TITLE: PUBLIC HEARING on a Class C Conditional Use Permit for the BT Campground Cabins and a Modest Plat: Lot Line Adjustment for BT II First Subdivision, 3rd Filing, Laramie County, WY.

PZ-26-00017 MODEST PLAT - LOT LINE ADJUSTMENT

RE: Response to Agency Review Comments: Simple Plat PZ-26-00017
BT Campground

RE: Response to Agency Review Comments: Conditional Use Permit PZ-26-00019
BT Campground

EXHIBIT B

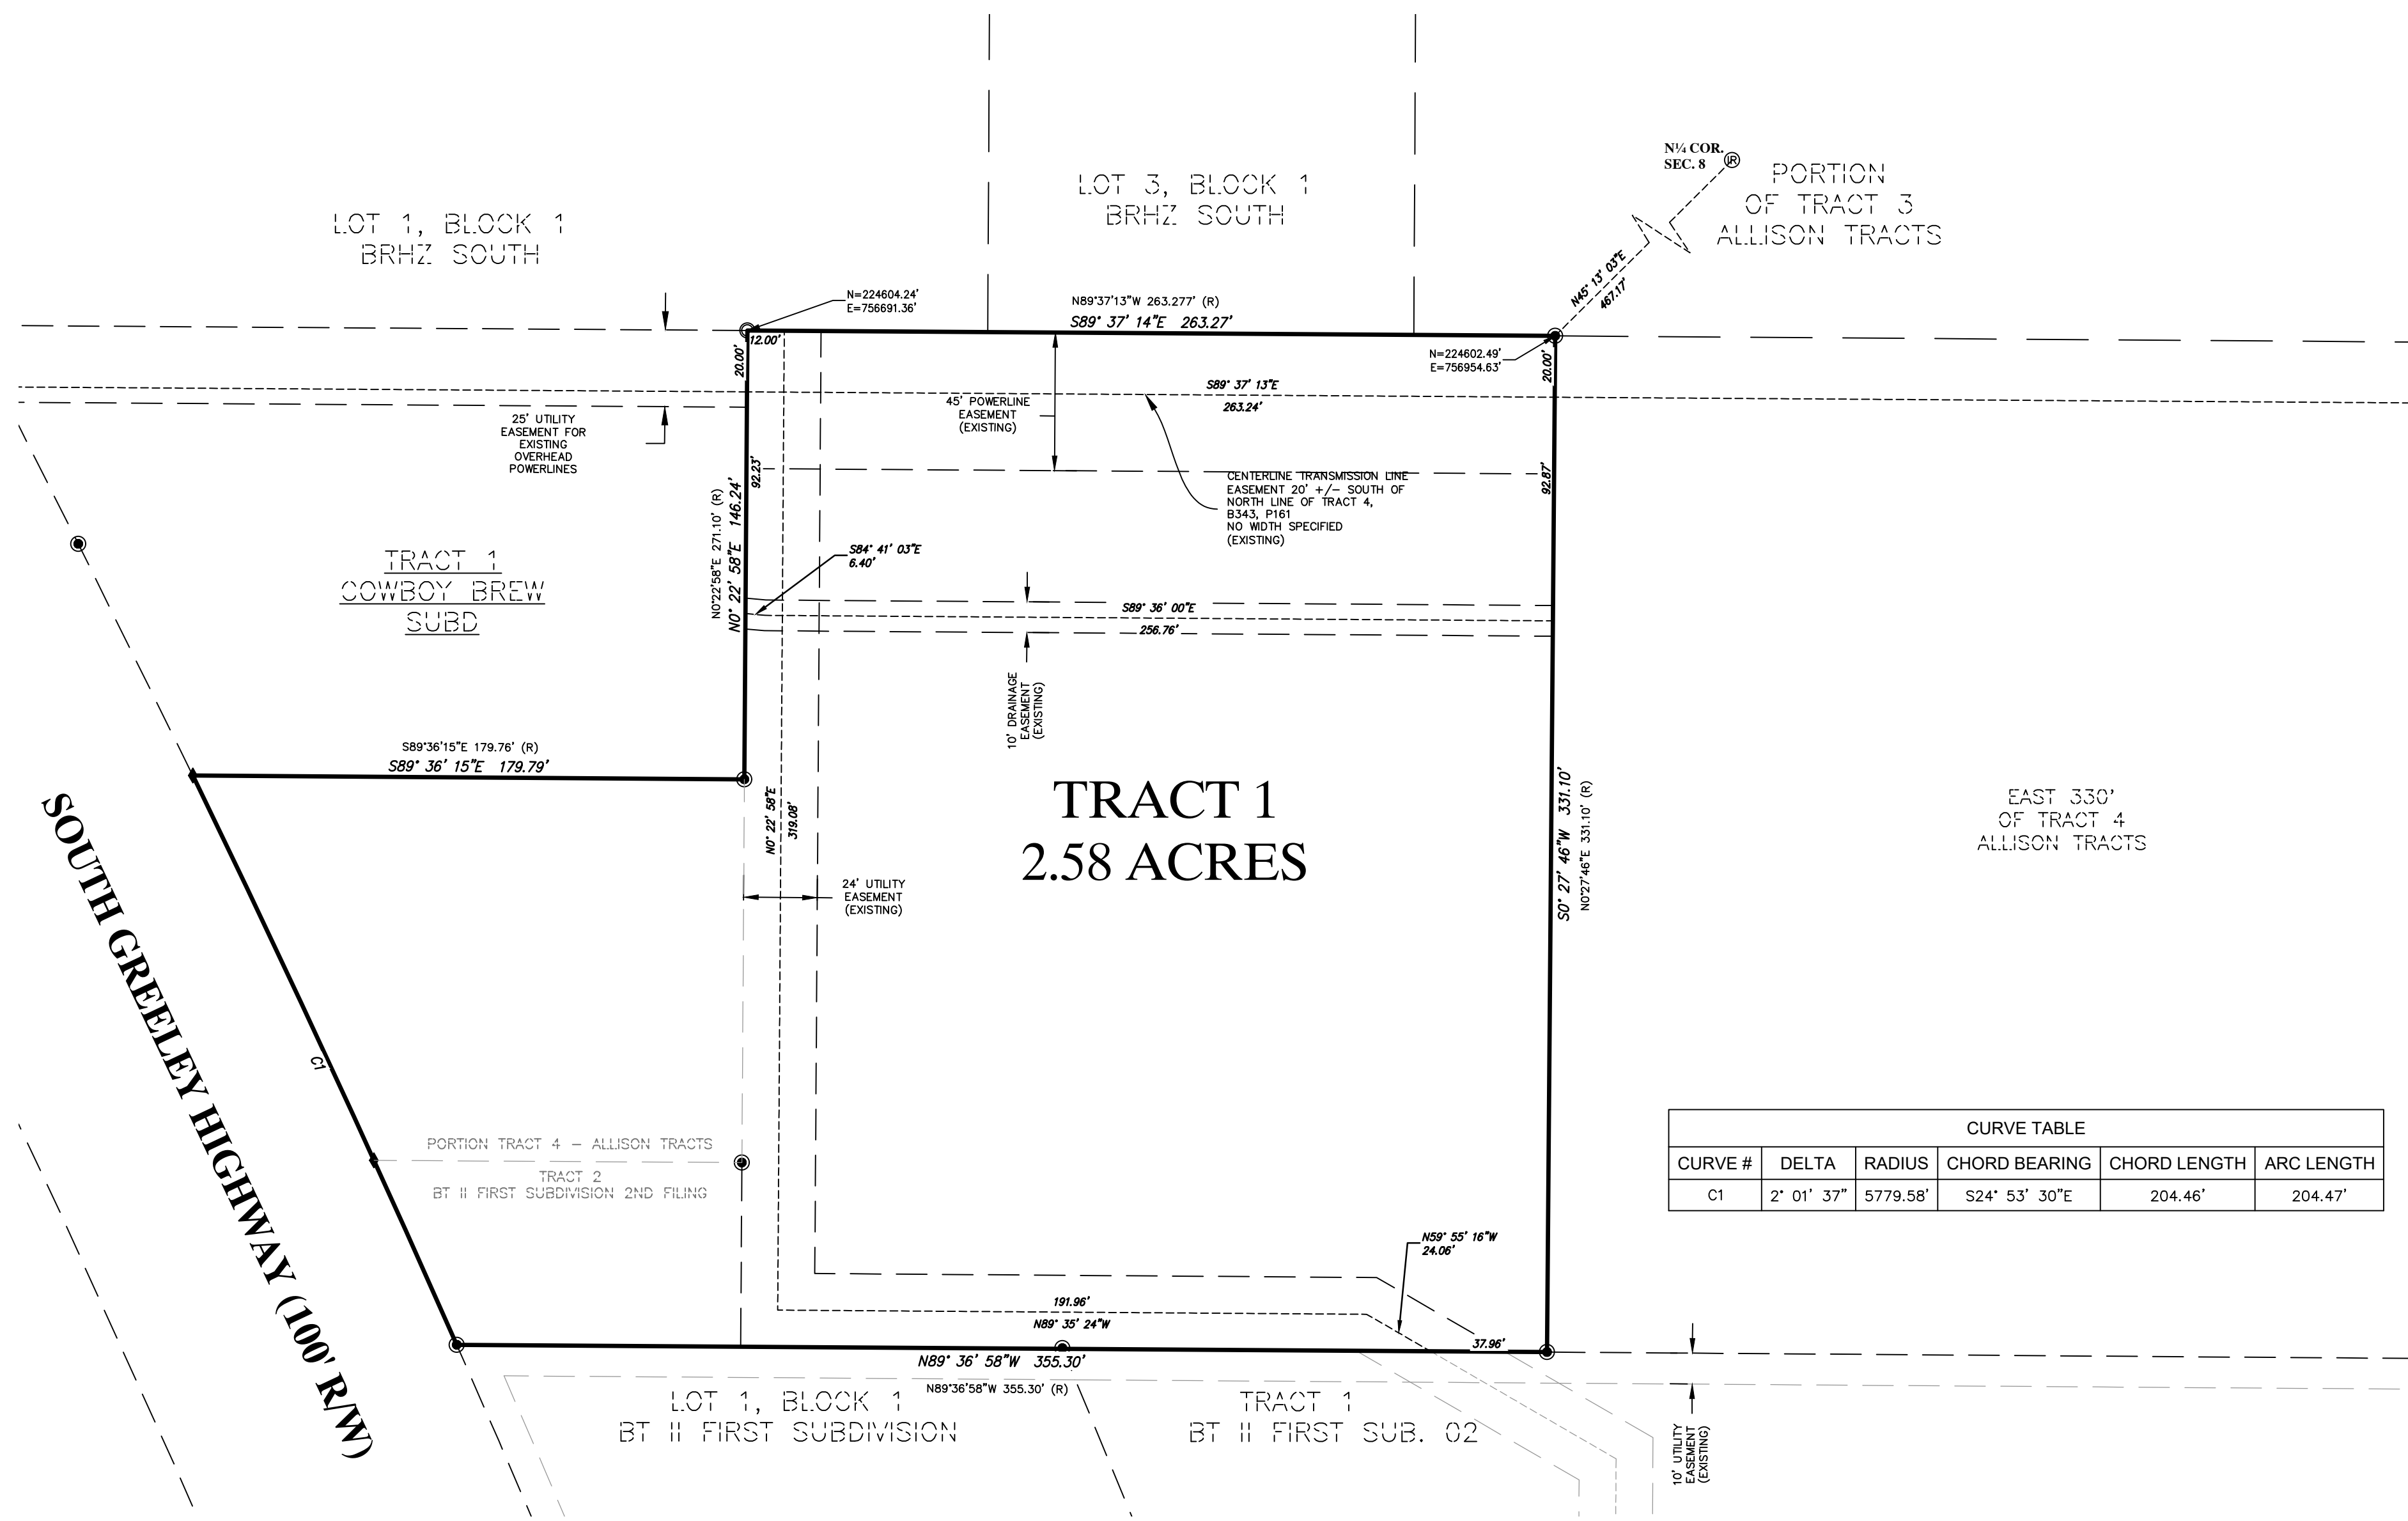
03/11/2026	Workflow	PUBLIC WORKS REVIEW	GENERAL	<p>1. A note shall be added to the plat indicating "there will be no public maintenance of internal roadways/access easements."</p> <p>1a. Internal roadways/access easements shall be built to the road standard (Section 5-6-109(f) pg 239 of the pdf and pg 234 in the bottom right and attached) within the Laramie County Land Use Regulations.</p> <p>2. All comments from the review engineer and surveyor shall be addressed and resolved appropriately.</p> <p>3. S Greeley Highway is under the jurisdiction of the Wyoming Department of Transportation (WYDOT). Any adjustments to the access for this tract shall be coordinated and approved by WYDOT.</p>	MOLLY.BENNETT@LARAMIECOUNTY.WY.GOV
03/11/2026	03/11/2026 Workflow	COUNTY REAL ESTATE OFFICE REVIEW	DEFICIENCY	Dick Marks and Lulie Adams-Marks need to sign as owners of the ptn of Tract 4 Allison Tracts, a Notice of Contract for Deed does not transfer ownership.	TERESA.LEMASTER@LARAMIECOUNTY.WY.GOV

03/24/2026		Application	PZ-26-00017	GENERAL	Added another review for County Assessor comments.	CATHERINE.CUNDA LL@LARAMIECO UNTYWY.GOV
03/24/2026	03/24/2026	Workflow	COUNTY ASSESSOR REVIEW	DEFICIENCY	1st Review: Dedication names BT II LLC as sole owner; however, a portion (PIDN 13660820100800, Por Tract 4, Allison Tracts) remains in a different owner of record. Documentation provided does not reflect a completed transfer of ownership. Please revise the dedication to reflect all owners of record.	CINDY.KEMIVES@ LARAMIECOUNTY WY.GOV

Date	Reviewer	Response to Comment
3.26.26	Cambia McCollom, GIS	The quadrant bearing in the Description has been corrected to add seconds rather than decimal minutes.

3.11.26	Molly Bennet, Public Works	<ol style="list-style-type: none">1. Plat note regarding public maintenance of internal roadways has been added to the plat2. Internal roadway / access easements re compliant with LCLUR3. Removal of accesses will be coordinated with WyDoT.
